802.3da Mixing Segment Specifications

March 2024

TCI 168.7 - suggested revision to IEEE P802.3da™/D1.0

TCI 168.8 suggested revision to IEEE P802.3da™/D1.0

Figure 168-17—Mixing segment and reference points

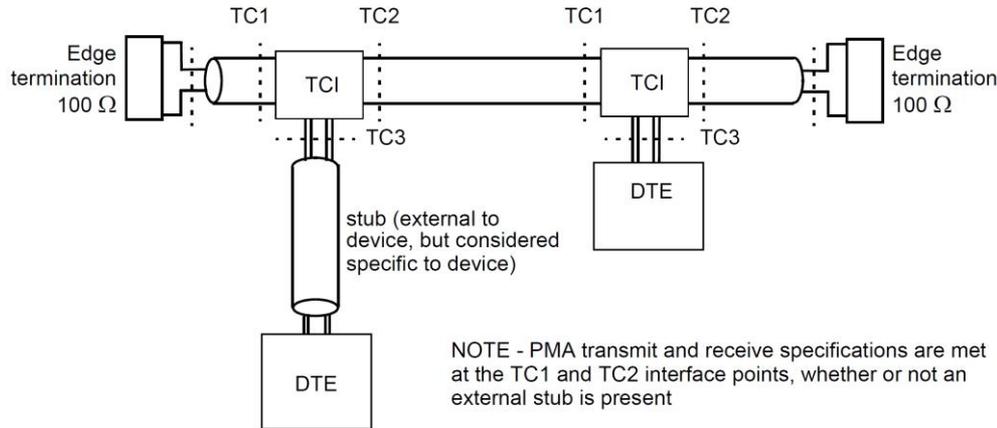
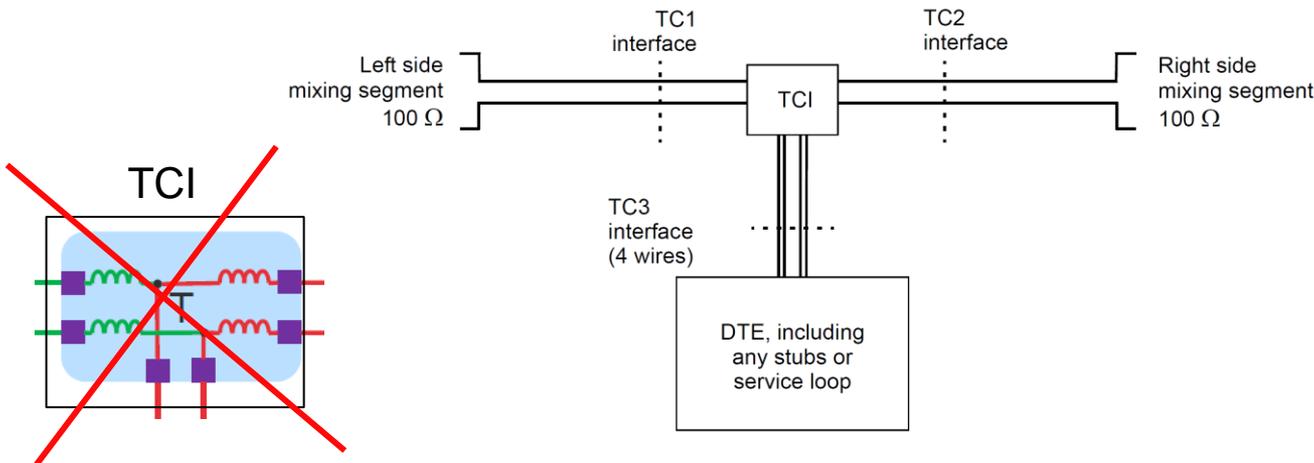
(1)>>Change text under 168.8 TCI specification line 34-36 and associated figure;

From: >>Each TCI has one interface facing each direction of the mixing segment (TC1 and TC2), and a four-wire interface facing the PMA (and any associated stub or service loop) (TC3) as shown in Figure 168–18.

The coax cable interface (MDI) to the shared media is not three interfaces..... treat TCI similarly...

To: Each TCI has one connection facing each direction of the mixing segment (TC1 and TC2), and a two-wire connection facing the PMA as shown in Figure 168-17 (slide 11). TC3 may not be accessible in an implemented system.

Figure 168–17—Mixing segment and reference points

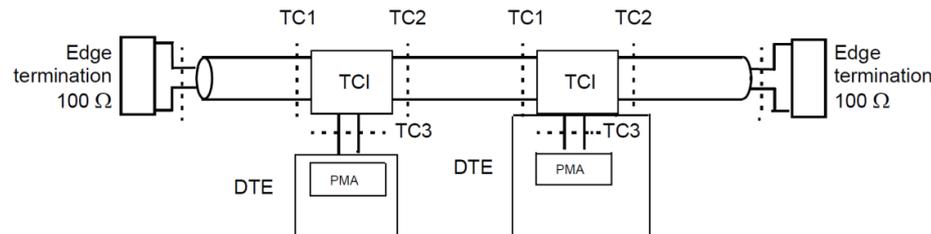
(2)>>Change text under 168.7 TCI specification line 8-11;

From: The mixing segment shall be a linear topology, with DTE attached at a TCI, where each TCI has two interfaces on the mixing segment, one interface facing in the direction of left edge termination of the mixing segment (TC1), and one facing in the direction of the right edge termination of the mixing segment (TC2), and a four-wire interface facing the PMA (and any associated stub or service loop) (TC3) (see Figure 168–18).

Changing to two-wire and removing service loops which can be implemented in trunk without calling it a TCI (four-wire)...

To:

The mixing segment topology has the PMA or PMA load connected to a TCI, where each TCI has two connections on the mixing segment, one connection facing in the direction of left edge termination of the mixing segment (TC1), and one facing in the direction of the right edge termination of the mixing segment (TC2), and a two-wire connection facing the PMA (and any associated stub) (TC3). TC3 may not be accessible in an implemented system.

NOTE - PMA transmit and receive specifications are met at TC1 and TC2.
